Final Environmental Statement

related to steam generator repair at
H. B. Robinson Steam Electric Plant,
Unit No. 2

Docket No. 50-261

November 1983

Figure 4.1 Exposure pathways to man

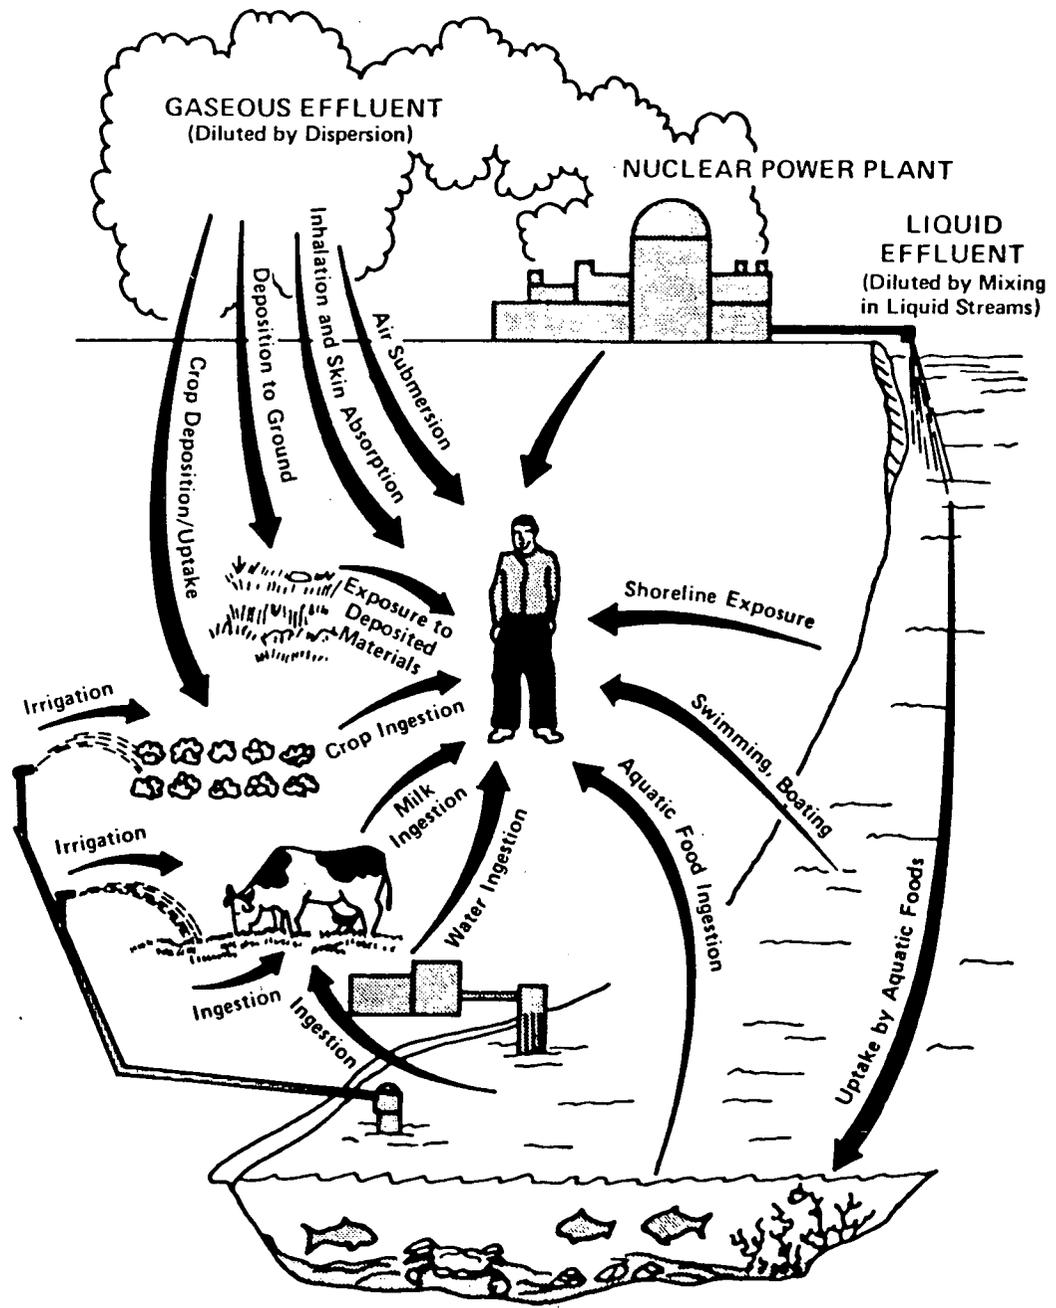
However, it would be helpful if a paragraph could be added to Section 4.1.2.1 (Doses from Effluents) that points out that the doses from the repair occur during the approximately 6 months refueling outage. Thus, the dose to individuals and populations will be the sum of the doses from normal operations and from steam generator repair. For instance, if the repair begins in January 1984, there would be 6 months of generator repair and 6 months of normal operations that would need to be summated to obtain the annual dose to compare with the radiation protection standards cited in this section.

2. The public radiation exposure as presented in Section 4.1.2, covers all possible emission pathways, as depicted in Figure 4.1, that could impact on the population in the environs of the facility. The dose computational methodology used in the estimation of radiation doses to individuals and populations within 80 km. of the plant have provided the means to make reasonable estimates of the doses resulting from normal operations. The results of these computations based on radioactive releases resulting from steam generator repair indicate that the doses are well within the radiation protection standards of 10 CFR, Part 20. However, it would be helpful if a paragraph could be added to Section 4.1.2.1 (Doses from Effluents) that points out that the doses from the repair occur during the approximately 6 months refueling outage. Thus, the dose to individuals and populations will be the sum of the doses from normal operations and from steam generator repair. For instance, if the repair begins in January 1984, there would be 6 months of generator repair and 6 months of normal operations that would need to be summated to obtain the annual dose to compare with the radiation protection standards cited in this section.
